Summary of Items Discussed in 3/2018 APSEC Discussion Forum on 25 May 2018

Items proposed by Convenors for Discussion	Summary of Discussion and BD's Responses
	Items raised by HKIA	
1.	<p><u>Flexibility for Solar Shading of Windows</u></p> <p>According to item 7 of ADF 2/2015 held on 20 March 2015, BD was receptive with the proposed sliding louvres in front of prescribed windows to enhance solar protection on a case-by-case basis subject to submission of detailed information of such system as well as the circumstances of individual cases. Further to the above, we would like to enquire if these external operable shading devices could also be taken into account in the RTTV assessment for residential buildings.</p>	<p>BD advised that whether such external operable shading devices could be taken into account in RTTV assessment would be considered on a case basis with due regard to the merits and circumstances of individual cases, as well as the following:</p> <ul style="list-style-type: none"> (i) External Shading Coefficient of the proposed device should be calculated with due reference to the methodology as stated in Section 2.5.3 of the "Guidelines on Design and Construction Requir

Scenario 1

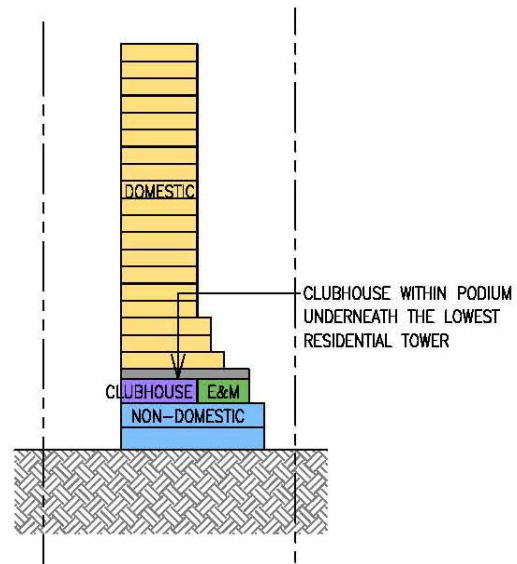
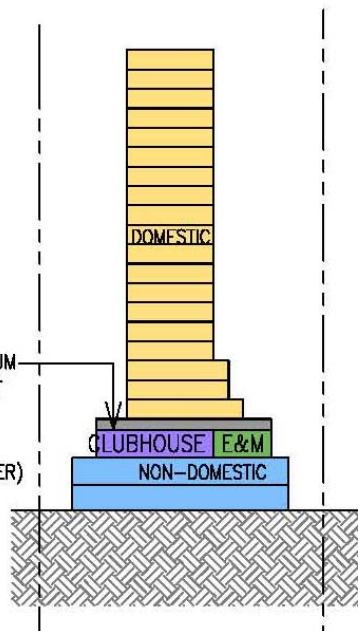
Item raised by AAP	
6.	<p><u>Site Coverage of Resident's Clubhouse under the application of PNAP APP-132</u></p> <p>We understand that the site coverage (SC) of resident's clubhouse has always been considered as non-domestic.</p> <p>We wish to know whether the determination will be different if clubhouse is located in a building which applied PNAP APP-132 for SC concession with building set back.</p> <p>It is our view that the determination should depend on the function of the premises and be unrelated to other circumstances. All uses within resident's clubhouse are non-domestic, and therefore non-domestic SC and GFA should always apply. We wish to know if our view is agreed.</p> <p>If the SC of resident's clubhouse is determined by circumstances other than its use, we wish to know whether the SC of the clubhouse in the following circumstances (all under PNAP APP-132) will be domestic SC or non-domestic SC.</p>	<p>BD confirmed that if the clubhouse was placed below the lowest domestic floor, its SC could be counted as non-domestic. However, if the clubhouse was placed within the domestic tower, its SC should be counted as domestic. The same principle should be applied in the context of PNAP APP-132.</p>
